**From:** Katelyn E. Sullivan  
**Sent:** October 29, 2021 11:30 AM  
**To:** Dianne Boisvert  
**Subject:** FW: MINCO Nbpt Crossing project - staff report to PB - site, landscaping and pedestrian/bicyclist circulation  
**Attachments:** 1. MINCO Nbpt Crossing - CCRT - images 2021.pdf

Staff report to the Planning Board re. review of the Smart Growth District (SGD) Plan Approval Application for 166-168 Route 1 (MINCO) Newburyport Crossing project:

Comments on site, landscaping and pedestrian/bicyclist circulation:

**Proposed Location of Commercial Tenant Sign – Needs Relocation**

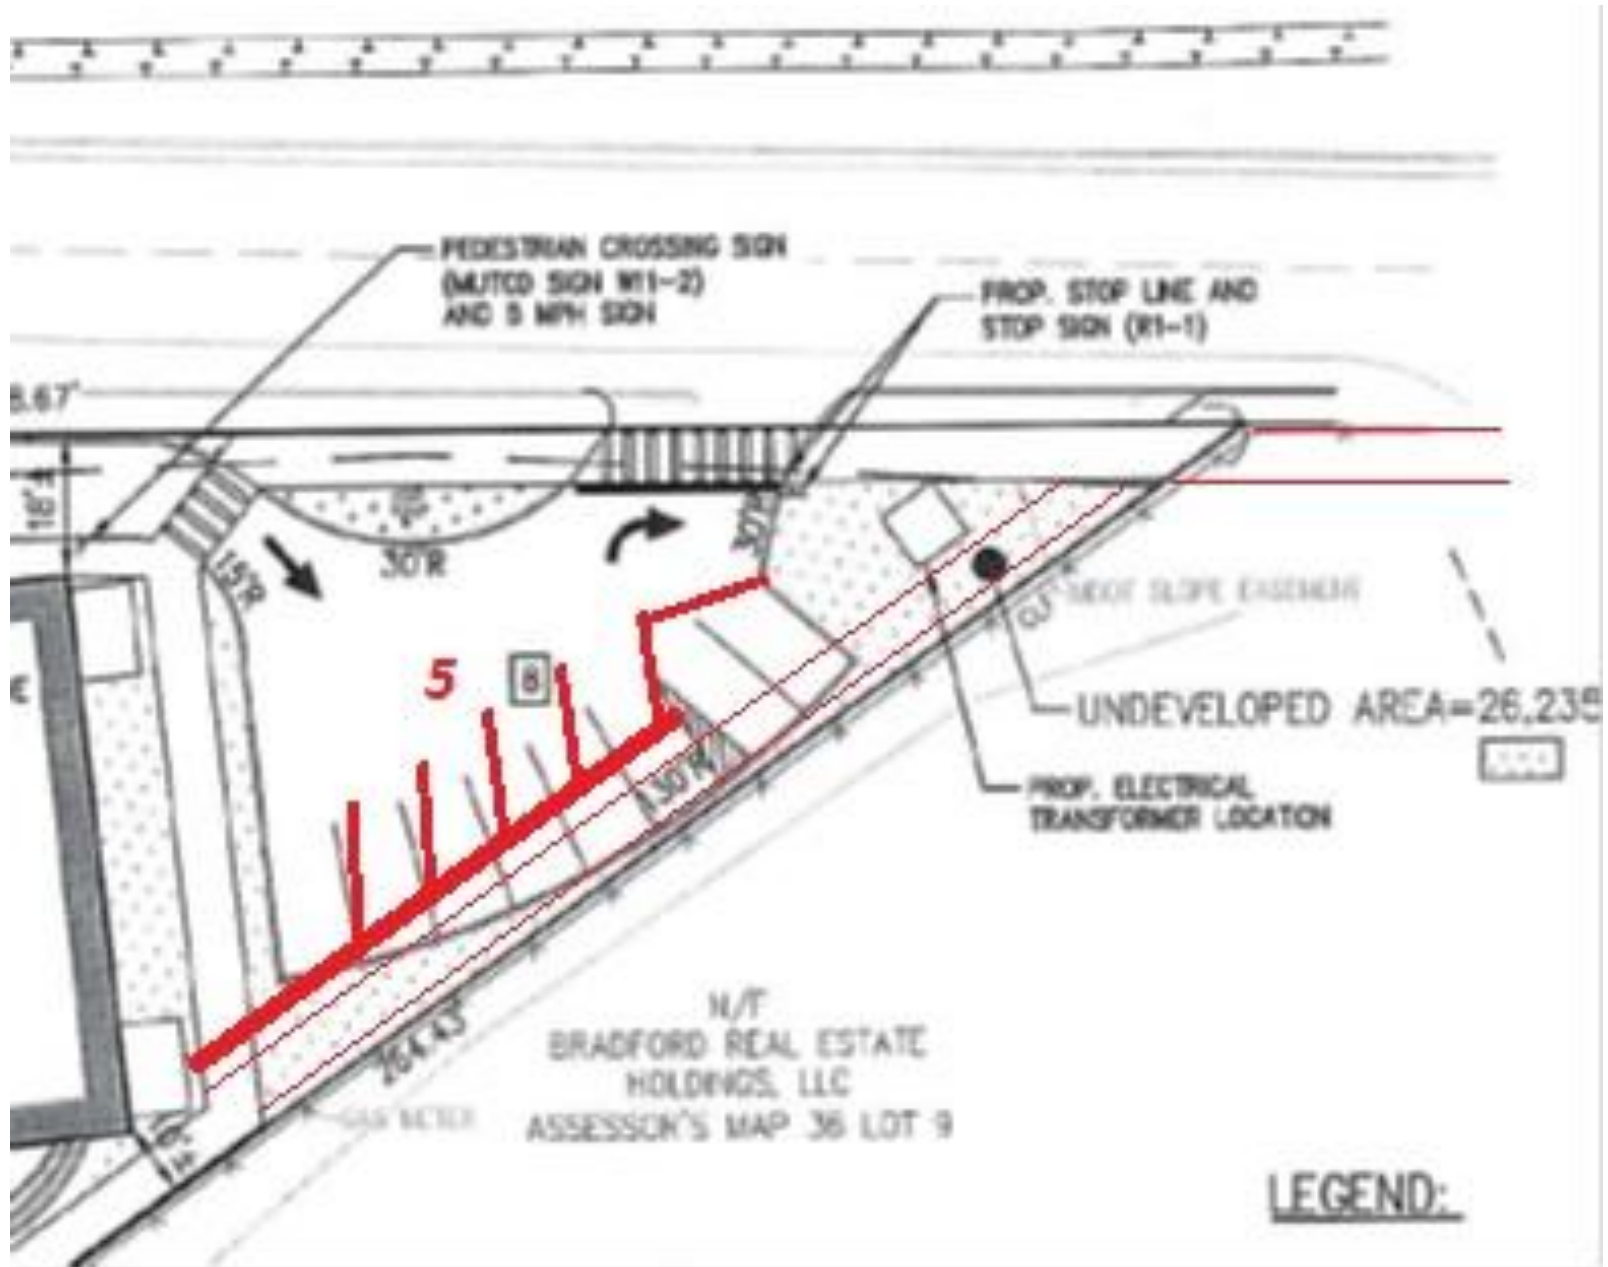
- Review and shift the location of the proposed commercial tenant sign approximately 50' south to remove it from the existing slope and group of smaller screening trees;
